VIRGINIA ELECTRIC AND POWER COMPANY
RICHMOND, VIRGINIA 23261

December 17, 2004

VIRGINIA ELECTRIC AND POWER COMPANY
SURRY POWER STATION UNITS 1 AND 2
PROPOSED TECHNICAL SPECIFICATIONS CHANGE REQUEST FOR
REACTOR COOLANT SYSTEM PRESSURE/TEMPERATURE LIMITS,
LTOPS SETPOINT, AND LTOPS ENABLE TEMPERATURE WITH
EXEMPTION REQUEST FOR ALTERNATE MATERIAL PROPERTIES BASIS PER
10 CFR 50.60(b)

ATTACHMENT 1
Discussion of Change

Figure 3.1-1: Surry Units 1 and 2 Reactor Coolant System Heatup Limitations (Heatup Rates up to 60 F/hr)
Applicable for the first 47.6 EFPY for Unit 1 and 48.1 EFPY for Unit 2 (Including Margins for Instrumentation Errors)

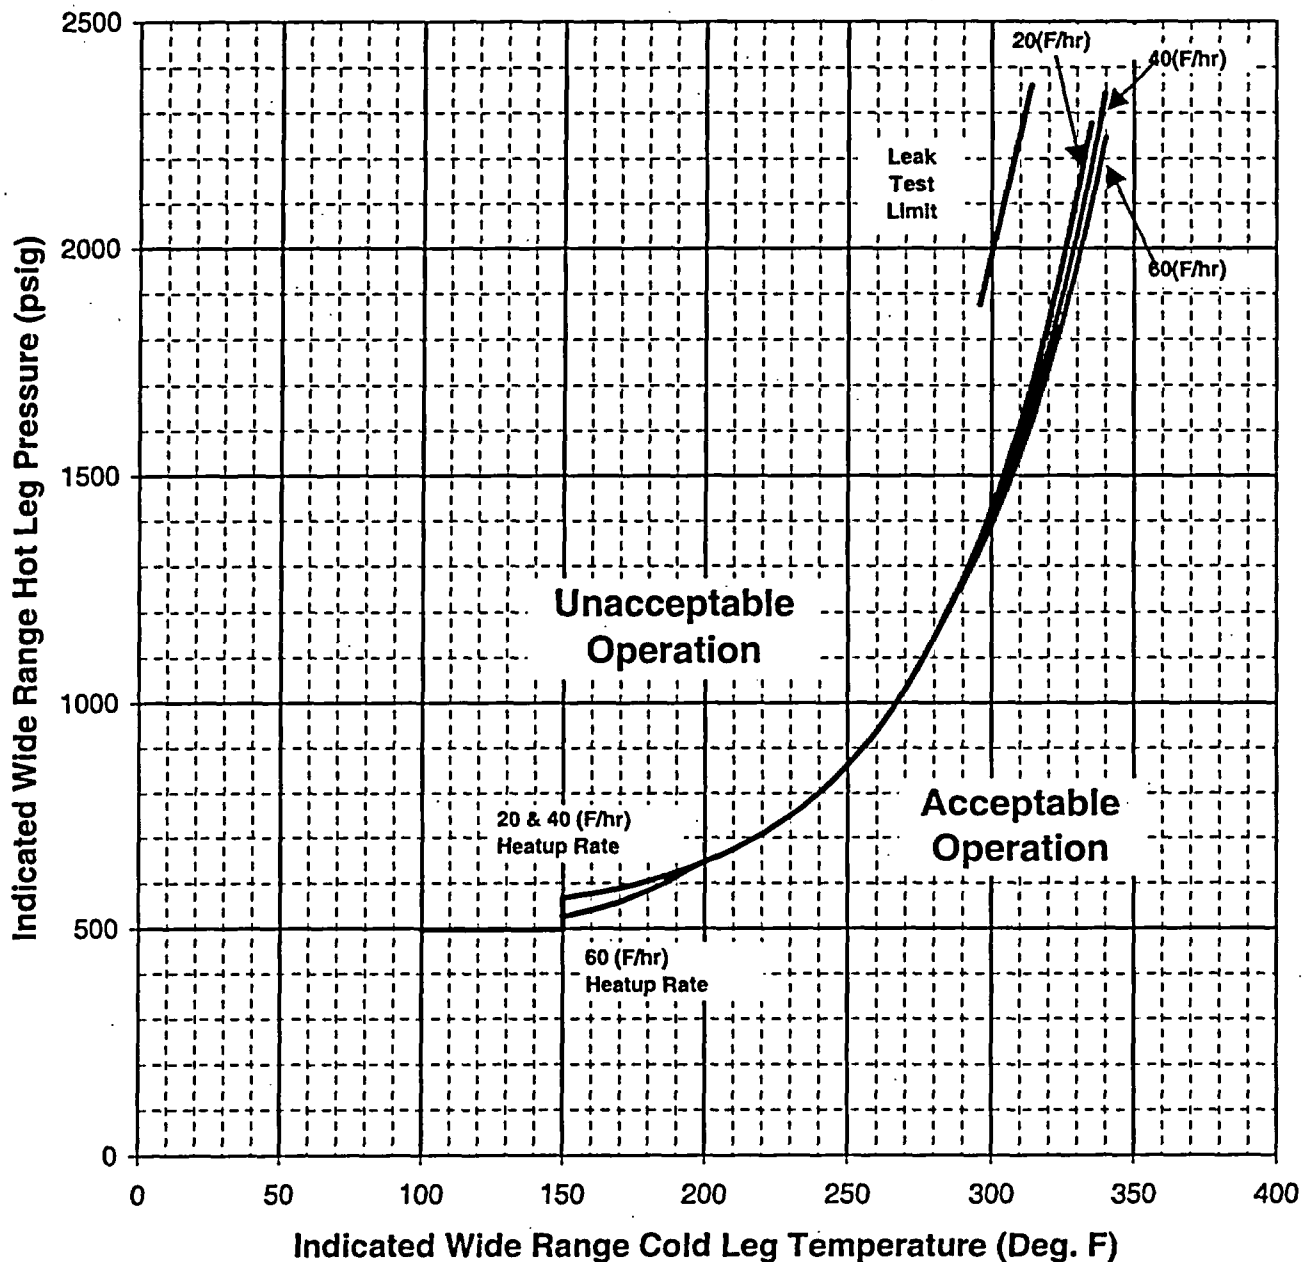
- **Technical Specification 3.1.B:** Figures 3.1-1 and 3.1-2 and the cumulative core burnup limits are being replaced by revised Figures 3.1-1 and 3.1-2, Reactor Coolant System Heatup and Cooldown Limitations. The proposed curves (provided in Appendix A) will be valid for both Surry Units 1 and 2. Note also that the axis labels have been clarified to identify the source of the parameter indication used (i.e., indicated wide range instrumentation). Basis changes reflect both the K_{1c} stress intensity formulation and the extended cumulative core burnup applicability limits.
- **Technical Specification 3.1.G.1.c(4):** This specification has been revised to reflect the proposed LTOPS setpoint value of 395 psig.
